## ADDENDUM #3

**Date Issued: March 27, 2018**

**NEW HAVEN PUBLIC SCHOOLS  
SCHOOL CONSTRUCTION PROGRAM**

1 MECHANICAL FLOOR PLAN - LEVEL 3 - AREA B  
1/8" = 1'-0"

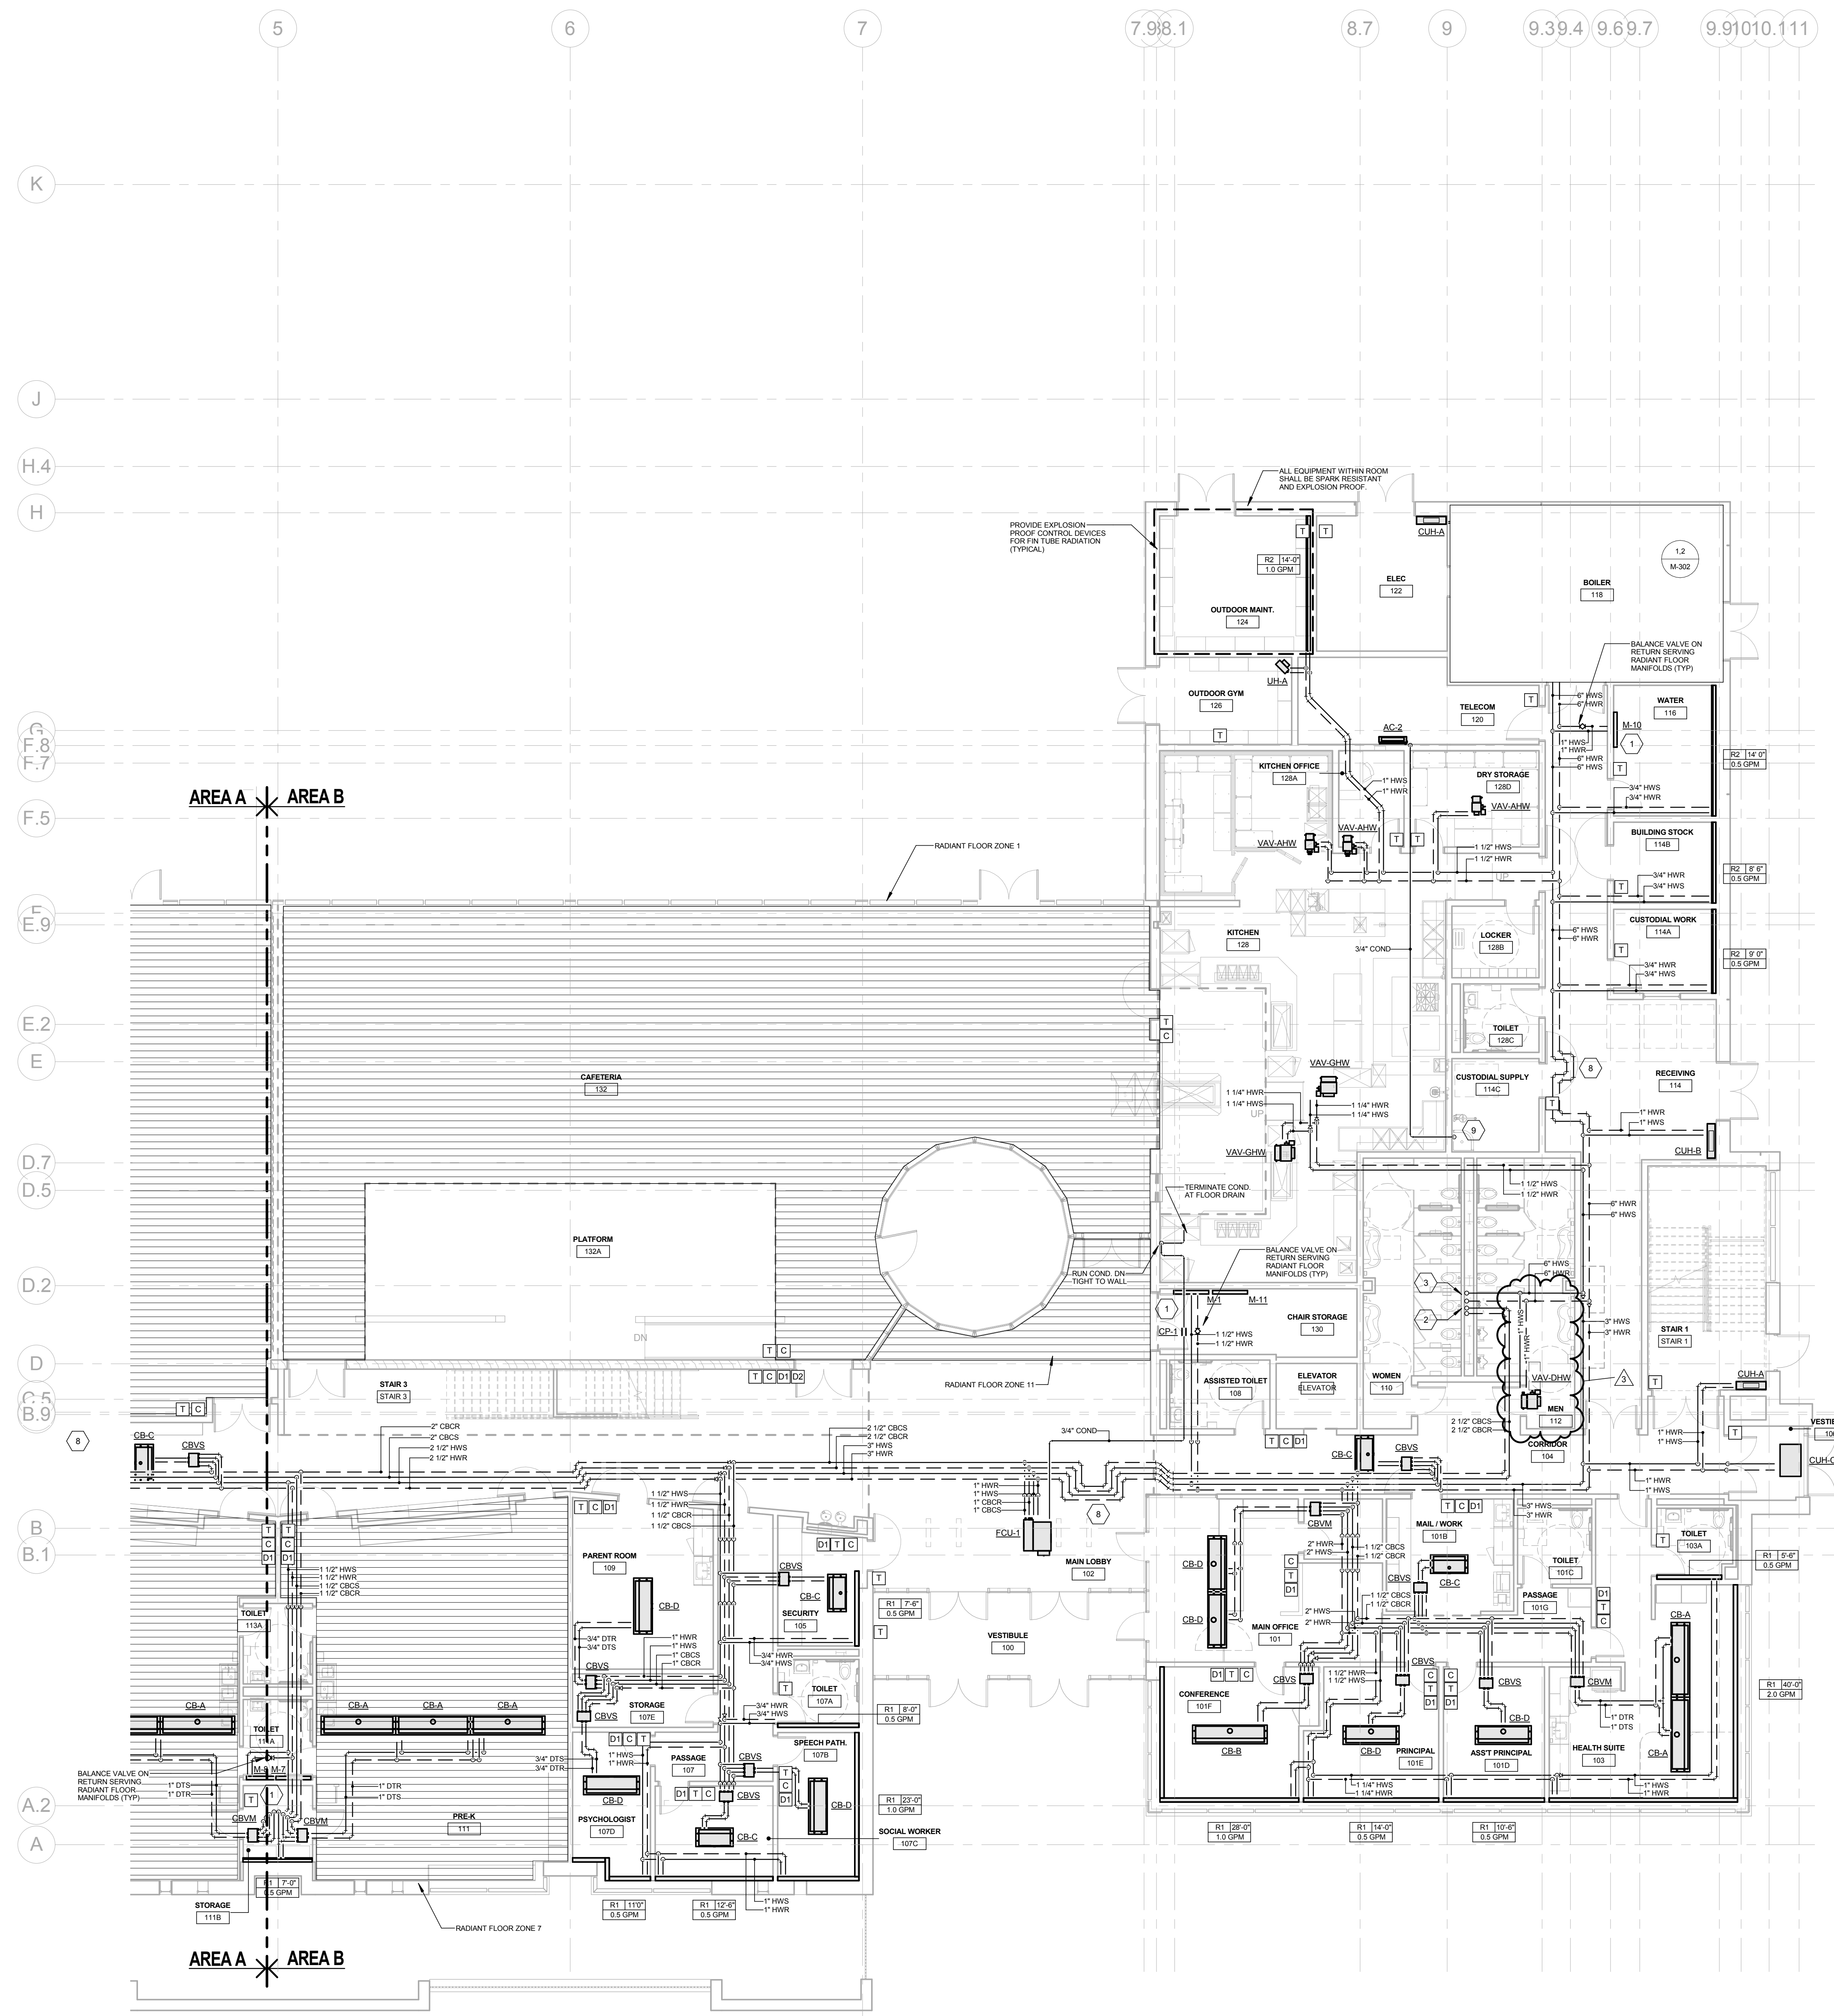
3. Boys 304B & Girls 304A
  - **CLARIFICATION:** Drawing M-132 & MP-132 VAV box serving Boys 304B & Girls 304A shall be type VAV-BHW
  - **ADD:** 1” Hot water supply and return piping to serve VAV-BHW within Boys 304B & Girls 304A.

8. **CLARIFICATION:** Section 4/M-300 was added to drawings to clarify the extent of work for Thermaduct exterior ductwork system.
9. **CLARIFICATION:** Hot water supply and return piping serving third floor was changed to 4” in lieu of 6” as shown on construction documents.

1 MECHANICAL PIPING FLOOR PLAN - LEVEL 2 - AREA B  
1/8" = 1'-0"

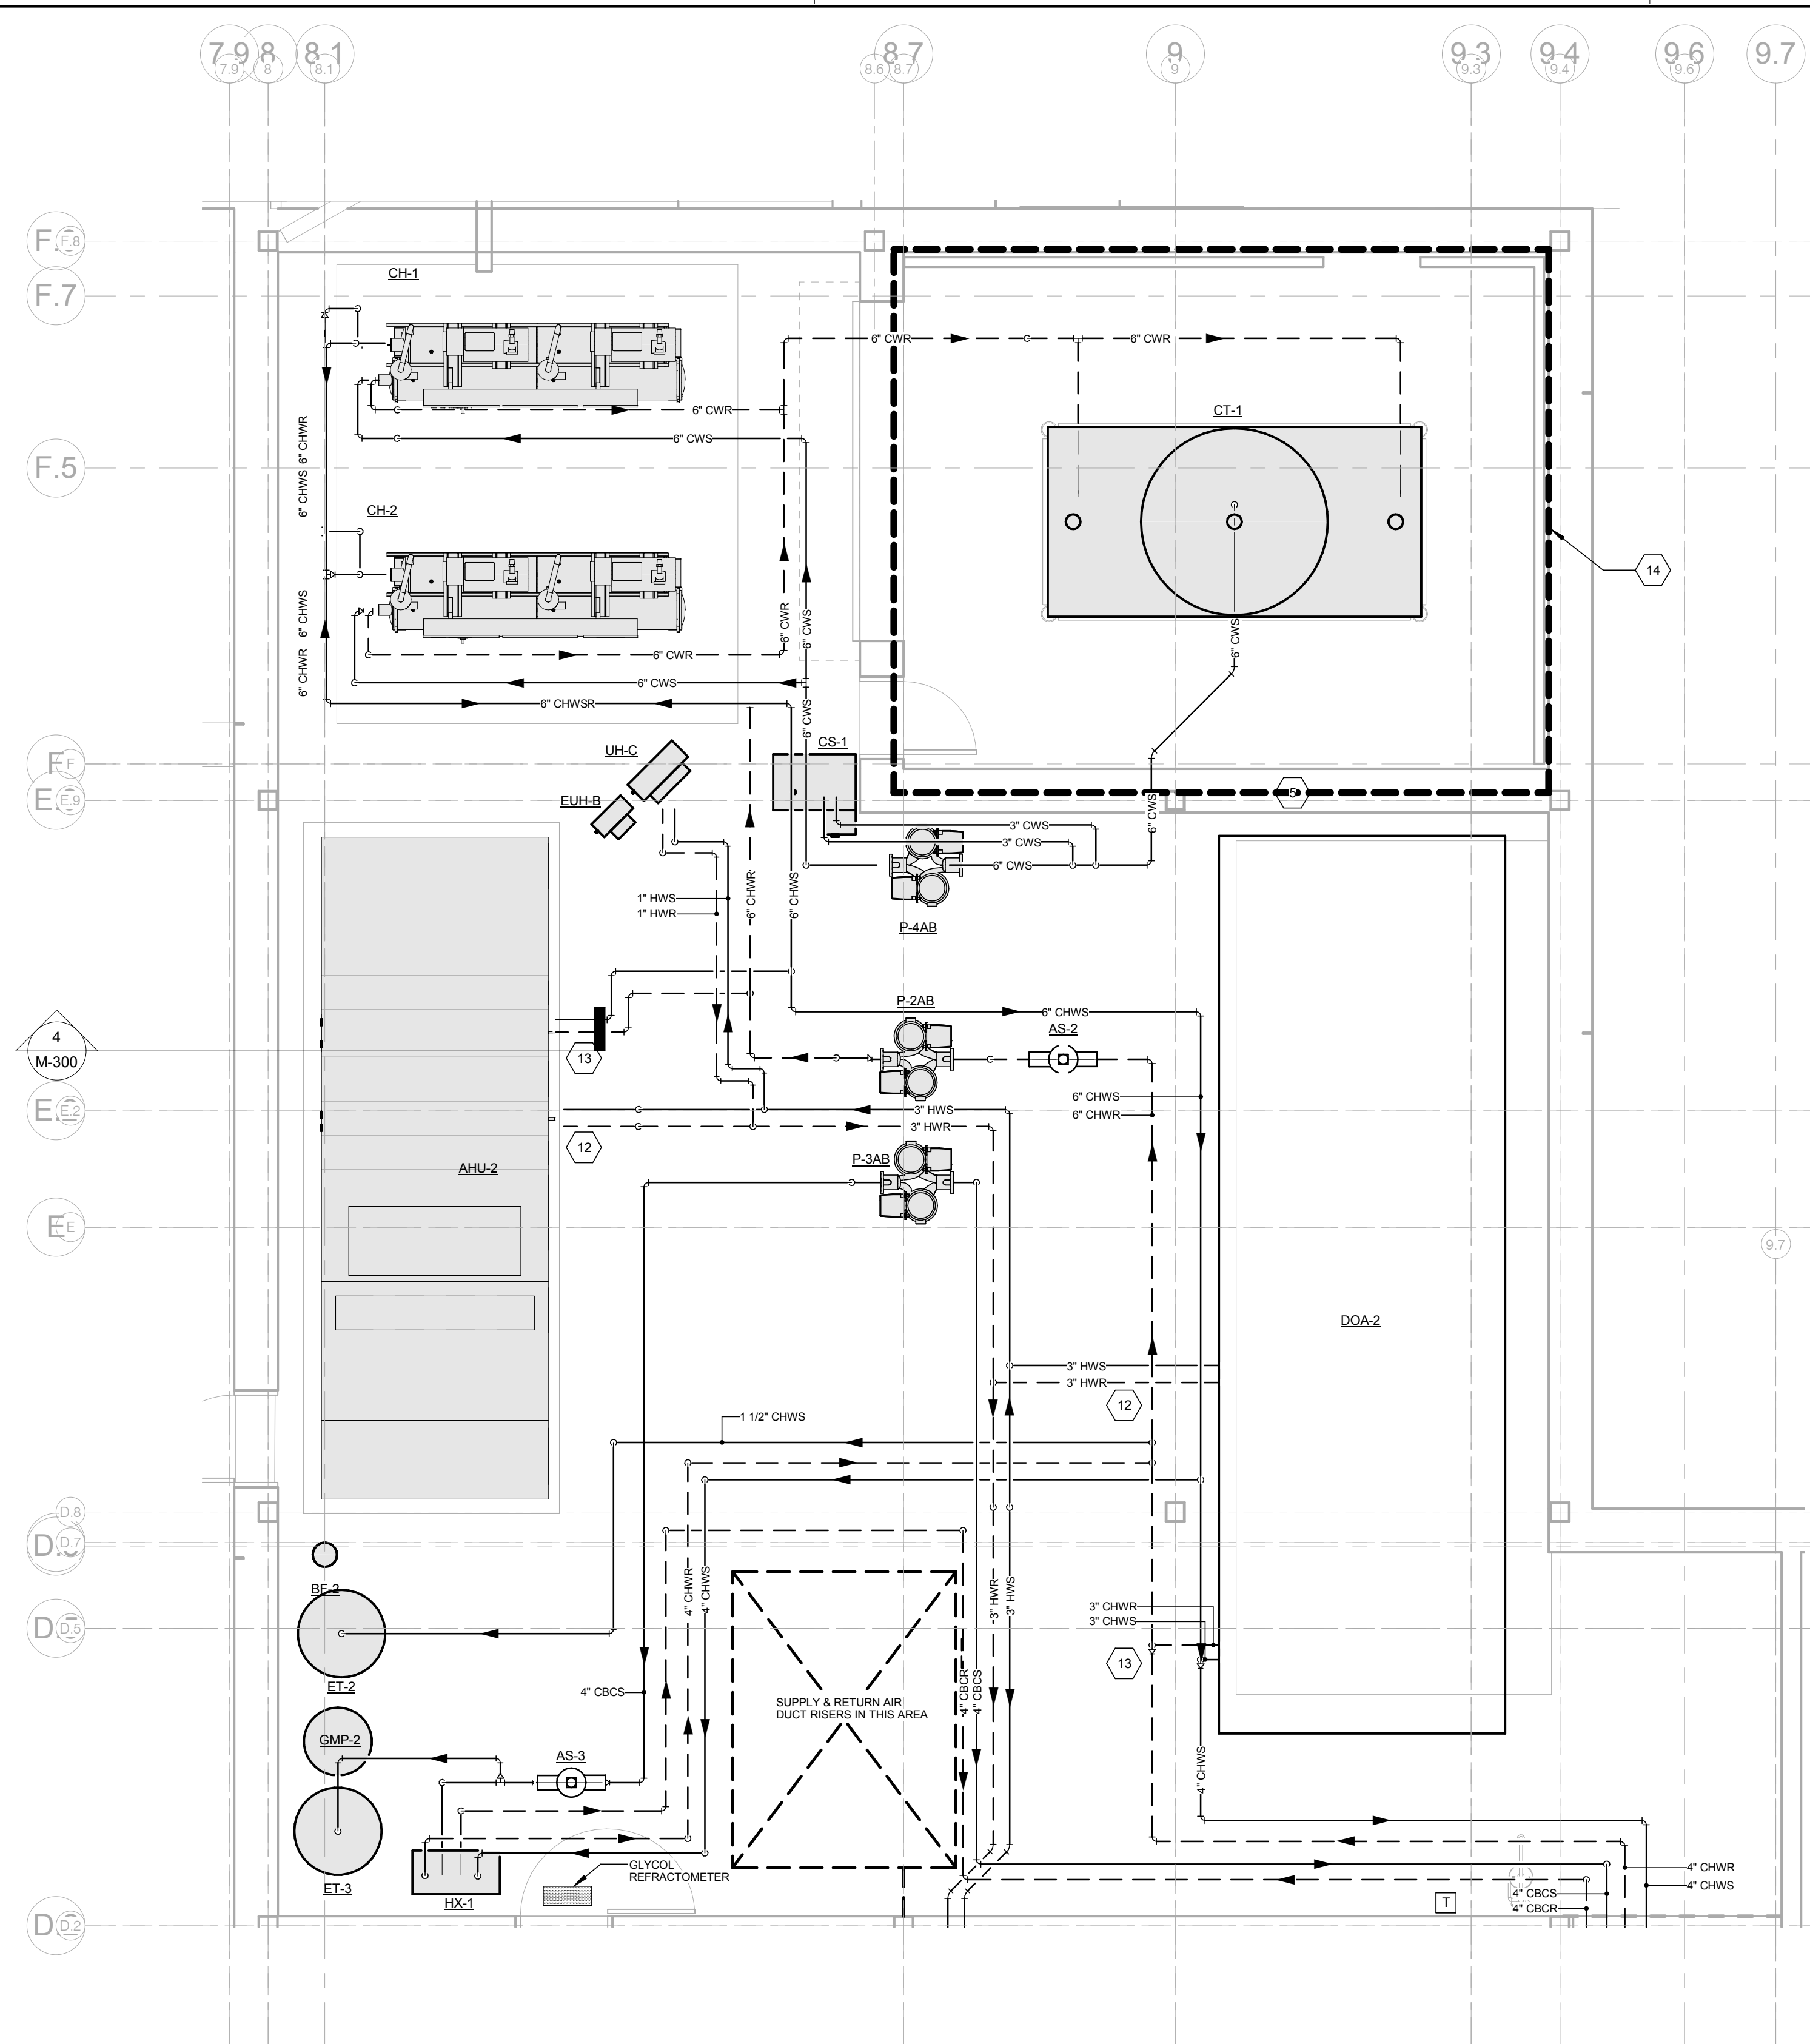
2. Boys 204B & Girls 204A
  - **CLARIFICATION:** Drawing M-122 & MP-122 VAV box serving Boys 204B & Girls 204A shall be type VAV-BHW
  - **ADD:** 1” Hot water supply and return piping to serve VAV-BHW within Boys 204B & Girls 204A.

4. **ADD:** Drawing M-601: add VAV-BHW to “Variable Air Volume Terminal Unit Schedule”.
5. **REVISE:** Hot water supply and return pipe sizes serving Cafeteria area VAV boxes. Refer to revised drawing MP-122 for updated pipe sizes.

29). [Ref: MP-122 & MP-132](#) - Note #4 on HWS&R riser states 4" HWS&R up to third floor (See drawing MP-122). However, 3rd floor plan (MP-132) shows 6" HWS&R piping coming out of this riser? Please verify if 4" or 6" is correct for this piping?

29). Ref: MP-122 & MP-132 - Note #4 on HWS&R riser states 4" HWS&R up to third floor (See drawing MP-122). However, 3rd floor plan (MP-132) shows 6" HWS&R piping coming out of this riser? Please verify if 4" or 6" is correct for this piping? - **CES Response: Refer to Addendum #3.**
